ARMIDALE DUMARESQ COUNCIL DA-219-2012 – SUPPLEMENTARY REPORT

JRPP No:	2012NTH025 – SUPPLEMENTARY REPORT 26 FEBRUARY 2013
DA No:	Armidale Dumaresq Council DA-219-2012
PROPOSED DEVELOPMENT:	<p>Development: New College for residential accommodation of 222 students at University of New England</p> <p>Address: Land within UNE Campus, at NW corner of Elm Avenue and Meredith Road, Armidale</p> <p>60 Madgwick Drive, Armidale, NSW 2350, Lot 10 DP 1142199</p>
APPLICANT:	Scot Brown (JBA Urban Planning Consultants Pty Ltd) on behalf of University of New England (with UNE's consent as property owner)
REPORT BY:	Stephen Gow, FPIA, Director Sustainable Planning and Living, Armidale Dumaresq Council

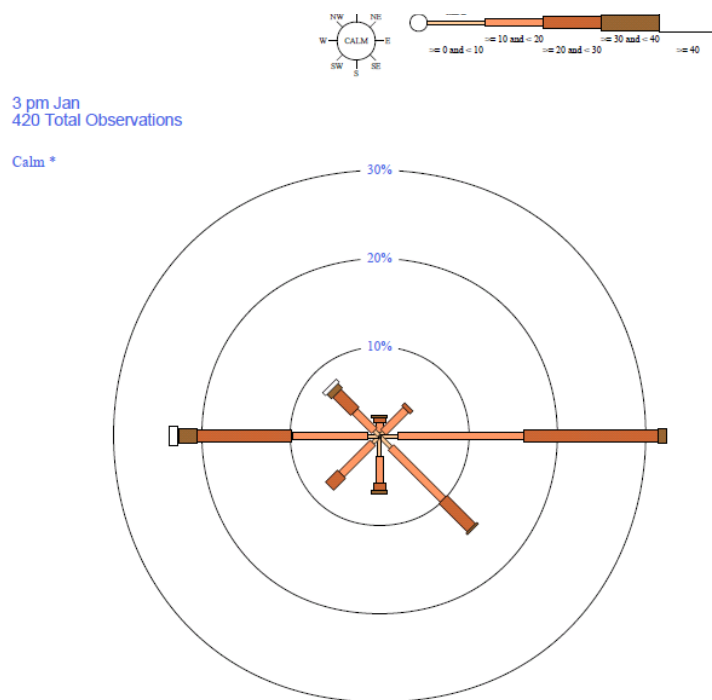
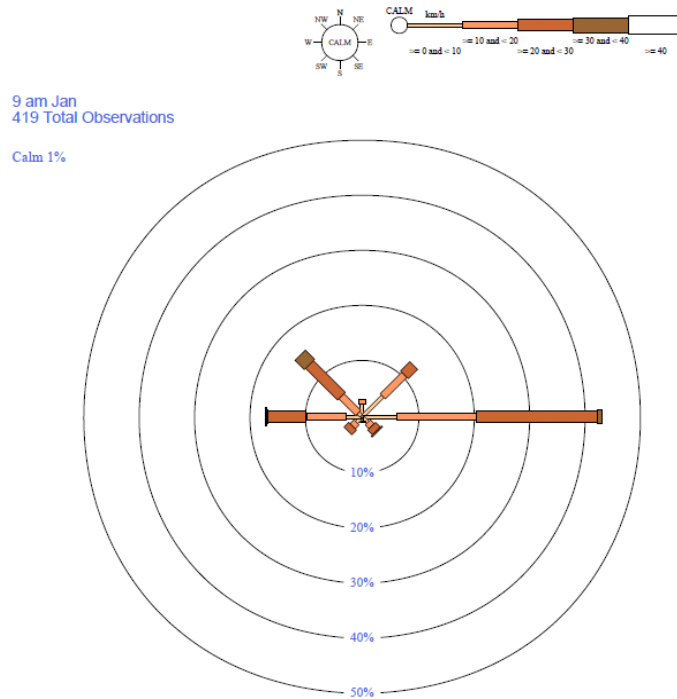
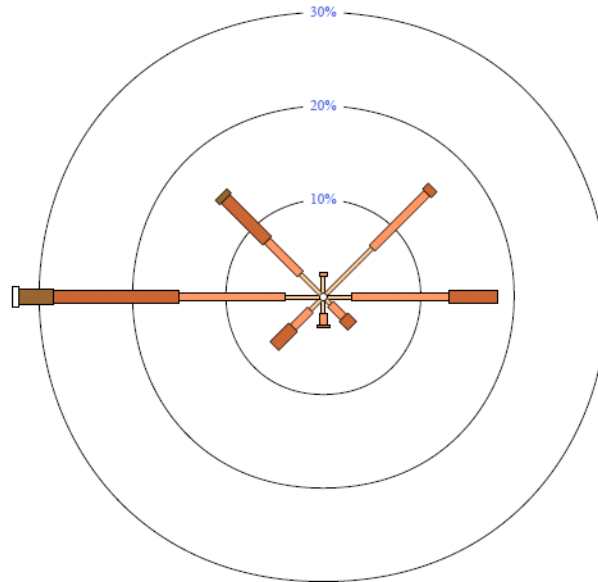
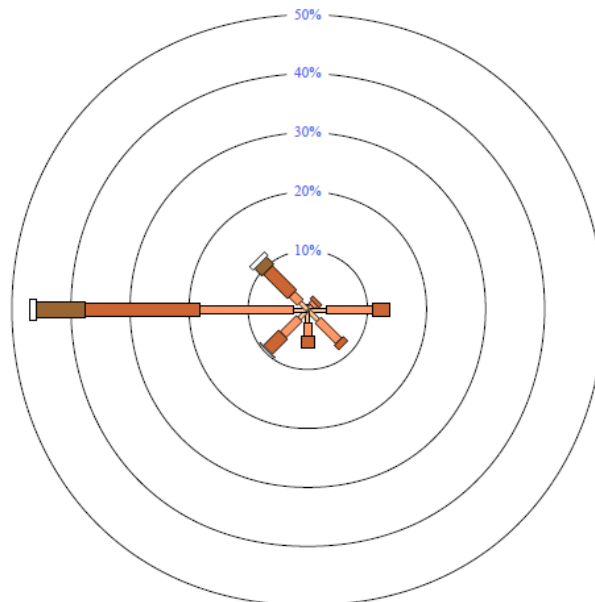
- 1) Wind protection/climate control for residents, as the prevailing winds are from the east and west (not as shown on the submitted site analysis plan DA 01.01 P5). He is concerned about a 'wind tunnel' effect in the winter months given the orientation of the proposed college blocks, which he distinguished from the enclosed courtyard design of the nearby existing colleges.

The submitted site analysis plan appears to be based on magnetic north instead of true north, so that the north point should be aligned approximately 11 degrees west of the position shown.

Moreover the prevailing wind direction for summer and winter in Armidale, as shown on the Bureau of Meteorology Wind Roses for Armidale Airport (January and July) are predominantly from the west and east:

The submitted site analysis does not reflect the correct compass orientation or related wind direction, so a revised drawing has been requested from the Applicant and should be available for tomorrow's meeting. However these changes would not significantly alter the submitted design concept.

As Mr McFarland has observed, in Armidale a key consideration is to provide shelter from cold (predominantly westerly) winter winds.

In the submitted design protection from the westerly winds would be afforded to the proposed central/eastern college courtyard by the section of 'Block A' aligned approximately north / south.

However the car park and the western courtyard would be relatively exposed, although the latter may receive some shelter from the proposed plant/storage building. This area could be further protected by new shelter plantings.

The eastern courtyard in turn may also benefit from additional shelter and screen plantings as suggested on the Site Analysis Plan, although further detail is required than has been shown to date on the submitted Landscaping Plans in SEE Appendix C.

Amend Condition 3 in the Appendix to the Assessment Report to require further details of screen plantings to offset prevailing wind action to the proposed college courtyard areas and car park in winter (see over with amended text highlighted in bold).

- (i) predominantly native species, in particular new yellow box and manna gum plantings, consistent with the recommendations in the Flora and Fauna Study submitted with the application (at p.42);
- (ii) **dense screen plantings to protect users of the car park and courtyard areas of the project from the effects of prevailing westerly and easterly winds.**
